**SUBJECT:** NuScale Power, LLC Submittal of Approved "-A" Version of Topical Report  
"Rod Ejection Accident Methodology," TR-0716-50350-A, Revision 3

“Rod Ejection Accident Methodology,” TR-0716-50350-P-A, Revision 3, Proprietary Version

“Rod Ejection Accident Methodology,” TR-0716-50350-NP-A, Revision 3, Nonproprietary Version

Figure 3-1 Calculation schematic for analyzing rod ejection accident

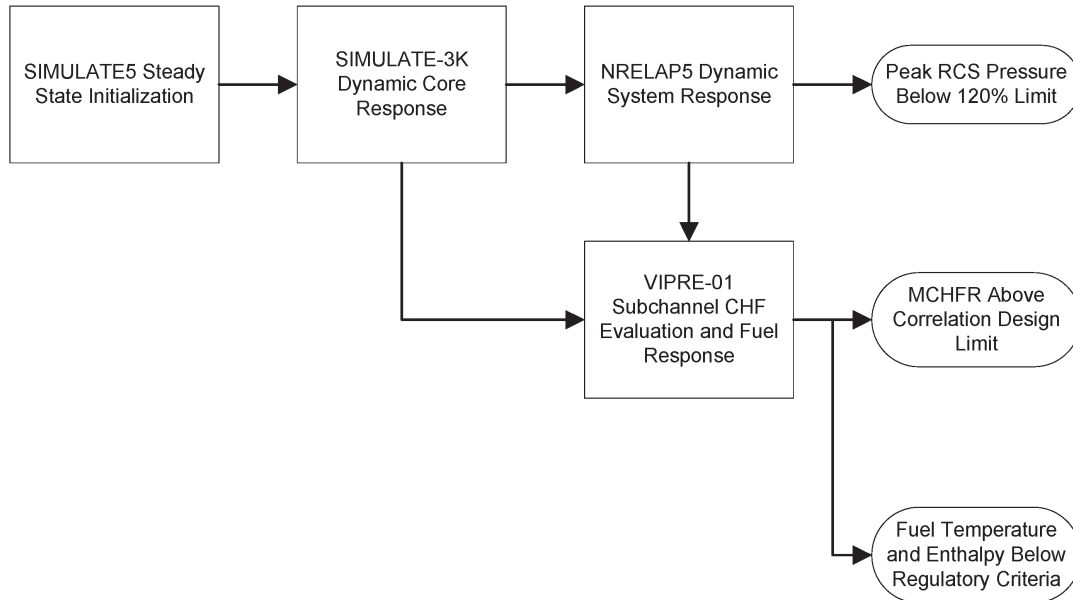
Section 3.2 of the TR describes the computer codes used in the NuScale methodology and the evaluation flow-path is shown in Figure 3-1. The analysis starts with the steady-state neutronics calculations performed with the methods using CASMO5/SIMULATE5 computer codes that the NRC staff approved in TR-0616-48793-P-A, Revision 1 (Reference 14). CASMO5 is used to generate a cross-section data library for use by the 3-D steady-state nodal code SIMULATE5 and 3-D transient analysis code SIMULATE-3K. SIMULATE5 initializes the cycle-specific model and reactor conditions that are used as input into the SIMULATE-3K evaluation.

Section 3 of the TR provides a general description of the computer codes that are used in the rod ejection analysis methodology and a flowchart to show the interfaces between different codes.
